## **Access Compliance Report Public Rights-of-Way** (Curb Ramps)

Intersection ID: 5295 Main Street: HARRIS HOUSTON RD **Cross Street: UNIVERSITY\_CITY\_BV** Location: NW ADA ID: D84990669B98 Ramp Type: Perp Initial Pass/Fail: Fail **Overall Compliance: No Severity Score:** 8.75

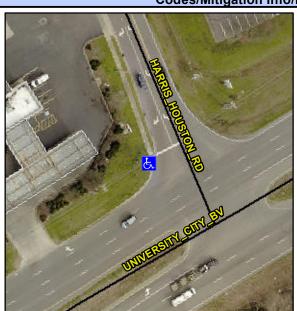
HARRIS HOUSTON RD Street 1 Name Stop Condition-Street 2 StopSign Street 2 Name N/A Stop Condition-Street 1 N/A Possible Solutions: Remove & Replace Entire Ramp. Surveyor Notes: N/A PROW/ADA: Not Found, R304.5.1

Field Measurements/Component Compliance						
Comp	liance Description	Data	Compl	iance	Description	Data
N/A	Ramp Length (in)	45.0	Yes	Ramp	Slope (%)	6.3
No	Ramp Width (in)	44.0	Yes	Ramp	XSlope (%)	0.1
N/A	Flare Type LT	N/A	N/A	Flare	Type RT	N/A
N/A	Flare Slope LT (%)	N/A	N/A	Flare	Slope RT (%)	N/A
N/A	Flare Traversable LT?	N/A	N/A	Flare	Traversable RT?	N/A
N/A	Landing Length (in)	N/A	N/A	DWS	Provided?	N/A
N/A	Landing Width (in)	N/A	N/A	DWS	Contrast?	N/A
N/A	Landing Slope (%)	N/A	N/A	DWS	Length (in)	N/A
N/A	Landing X Slope (%)	N/A	N/A	DWS	Full Width?	N/A
N/A	Landing Curb? (Y/N)	N/A	N/A	DWS	Offset (in)	N/A
N/A	Shared Landing?	N/A				
N/A	Gutter Ponding?	N/A	N/A	Gutte	r Slope (%)	N/A
N/A	Gutter Lip Ht (in)	N/A	N/A	Gutte	r X Slope (%)	N/A
N/A	Painted X Walk1?	No	N/A	Paint	ed X Walk2?	N/A
	X Walk 1 Direction	To S		X Wa	lk 2 Direction	N/A
N/A	X Walk 1 Width (in)	N/A	N/A	X Wa	lk 2 Width (in)	N/A
	X Walk 1 Slope (%)	1.2		X Wa	lk 2 Slope (%)	N/A
